Groundwater and Wastewater Services File Imaging Project

SOIL/SITE EVALUATION
for ON-SITE WASTEWATER SYSTEM

OWNER: Hannah Creighton APPLICANT: _____
ADDRESS: 2618 Selwyn Ave, Charlotte, N.C. DATE EVALUATED: 5-3-99
PROPOSED FACILITY: residence PROPOSED DESIGN FLOW (.1949) 360gpd PROPERTY SIZE: .64
LOCATION OF SITE: Springfield Farms PROPERTY RECORDED: _____
WATER SUPPLY: ☒Private ☐Public ☐Well ☐Spring ☐Other _____
EVALUATION METHOD: ☐Augur Boring ☒Pit ☐Cut
TYPE OF WASTEWATER: ☒Sewage ☐Industrial Process ☐Mixed

Re: Springpoint Lane
File: 2895B
Parcel: PO 199-211-01

FILE # 26951

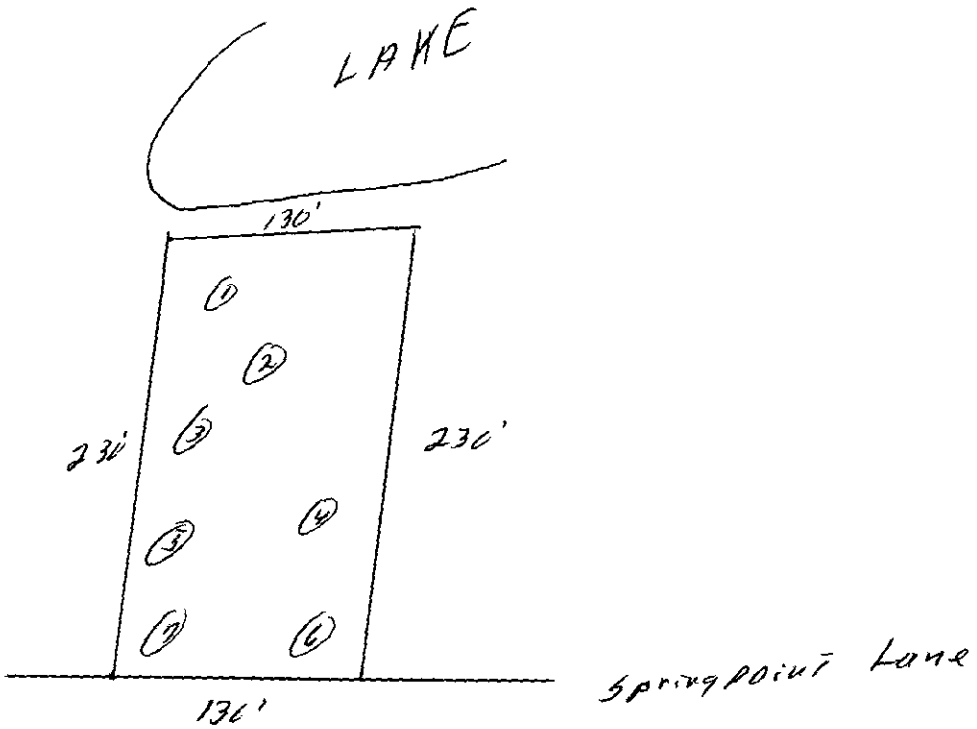
PROFILE #	Slopes 5-12% .1940 Landscape Position/ Slope %	Horizon Depth (IN.)	SOIL MORPHOLOGY (.1941) .1941 STRUCTURE/ TEXTURE	SOIL MORPHOLOGY (.1941) .1941 CONSISTENCE MINERALOGY	OTHER PROFILE FACTORS .1942 SOIL WETNESS/ COLOR	OTHER PROFILE FACTORS .1943 SOIL DEPTH	OTHER PROFILE FACTORS .1956 SAPRO CLASS	OTHER PROFILE FACTORS .1944 RESTR HORIZ	PROFILE CLASS &LTAR
1	LS	0-5"	gr/lcl	FR/SEXP/SS/SP	>19" TO soil wetness	19"	N/A	None	US
		5-19"	SBK ABK/lc	VF:/Mixed//VS/VP					
2	LS	0-6"	gr/lcl	Fr/SEXP/SS/SP	>19" TO soil wetness	15"	N/A	None	US
		6-15"	SBK ABK/lc	VF:/Mixed/VS/VP					
3	LS	0-5"	gr/lcl	Fr/SEXP/SS/SP	> 51" TO soil wetness	51"	N/A	None	US
		5-51"	SBK ABK/lc	VF:/Mixed//VS/VP					
4	LS	0-6"	gr/lcl	Fr/SEXP/SS/SP	> 36" TO soil wetness	36"	N/A	None	US
		6-36"	SBK ABK/lc	F:/SEXP/VS/VP					
5	LS	0-4"	gr/lcl	Fr/SEXP/SS/SP	> 36" TO soil wetness	36"	N/A	None	RS .2g(Fa) IE
		4-36"	SBK/lc	F:/SEXP/SP					
6	LS	0-3"	gr/lcl	Fr/SEXP/SS/SP	>23" TO soil wetness	23"	N/A	None	US

3-23"	SBK/lc	VF:/Mixed//VS/VP					
7	LS	0-3"	gr/lcl	Fr/SEXP/SS/SP	>25" TO soil wetness	25"	N/A	None	US
		3-25"	SBK/lc	VF:

DESCRIPTION	INITIAL SYSTEM	REPAIR SYSTEM
Available Space (.1945)	US	US
System Type(s)		
Site LTAR

OTHER FACTORS (.1946): _____
SITE CLASSIFICATION (.1948): Unsuitable
EVALUATED BY: W.R. Marlin 3-26-99
OTHER(S) PRESENT: LSS

COMMENTS 1067 Repair

FILE # 2895D

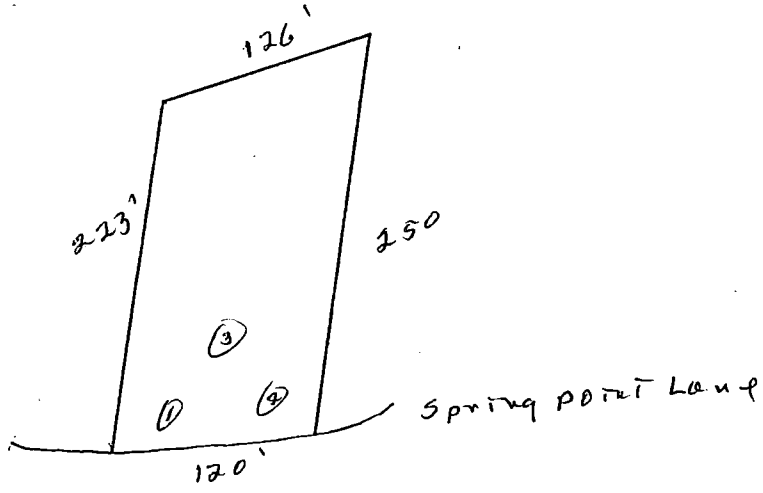
COMMENTS # 100% Repair
